Fenster Farm Subdivision Phase 3

Fenster Farms Subdivision Phase 3
PART OF THE SE QUARTER OF SECTION 7, T.6N., R.2W., S.L.B & M., U.S. SURVEY
WEBER COUNTY, UTAH

Preliminary Design

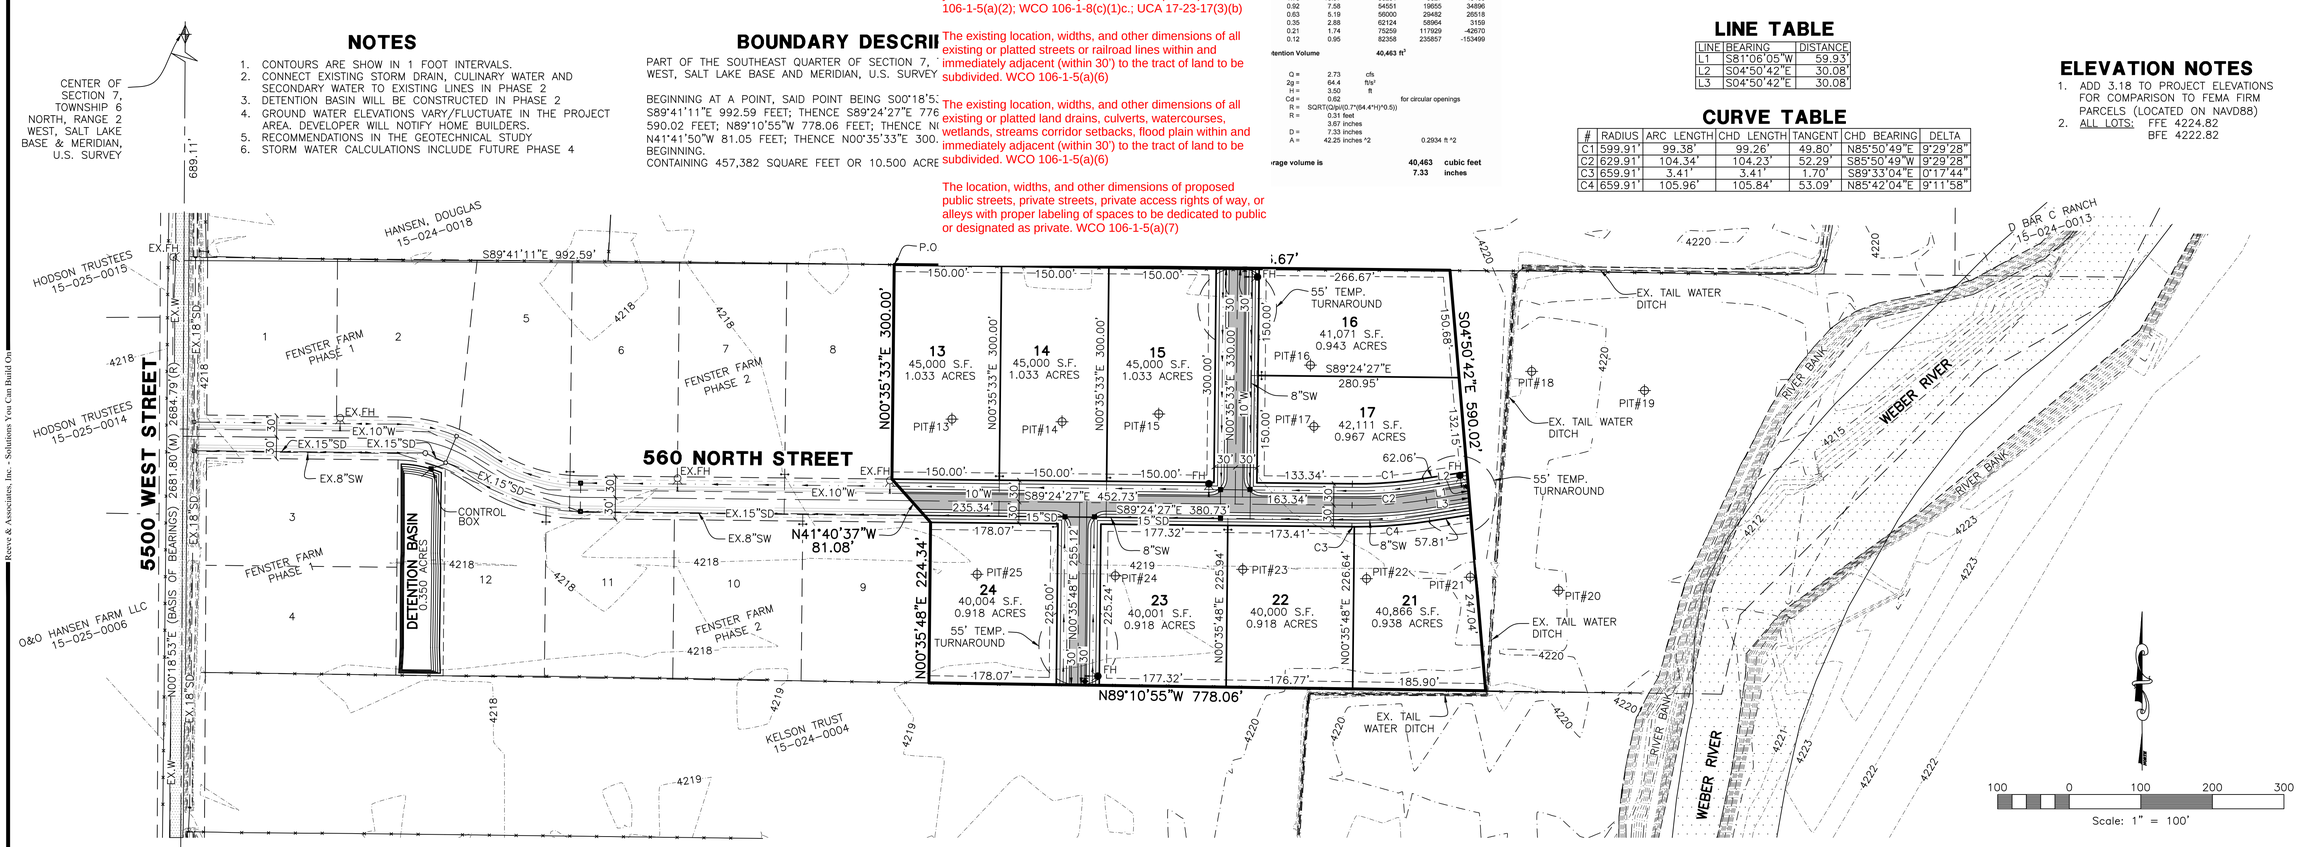
PLEASE RE-APPLY ALL COMMENTS GIVEN BEFORE BOUNDARY WAS CHANGED THAT HAD BEEN RESOLVED WITH PREVIOUS SUBMITTALS. SOME ARE LISTED BELOW, BUT SEE PREVIOUS REVIEWS AS WELL.

Subdivision Name in bold letters at the top of the sheet. WCO 106-1-5(a)(1); WCO 106-1-8(c)(1)a

General Location of the Subdivision in bold letters at the top of the sheet. (e.g. City, County, State) WCO 106-1-5(a)(1); WCO 106-1-8(c)(1)a

The Township, range, and quarter section of the Subdivision in bold letters at the top of the sheet. WCO 106-1-5(a)(1); WCO 106-1-8(c)(1)a.; UCA 17-23-17(3)(a)

Date of the survey noted in the heading (Meaning the date, year and month the survey markers were placed). WCO 106-1-5(a)(2); WCO 106-1-8(c)(1)c.; UCA 17-23-17(3)(b)

The existing location, widths, and other dimensions of all existing or platted streets or railroad lines within and immediately adjacent (within 30') to the tract of land to be subdivided. WCO 106-1-5(a)(6)

The existing location, widths, and other dimensions of all existing or platted land drains, culverts, watercourses, wetlands, streams corridor setbacks, flood plain within and immediately adjacent (within 30') to the tract of land to be subdivided. WCO 106-1-5(a)(6)

The location, widths, and other dimensions of proposed public streets, private streets, private access rights of way, or alleys with proper labeling of spaces to be dedicated to public or designated as private. WCO 106-1-5(a)(7)
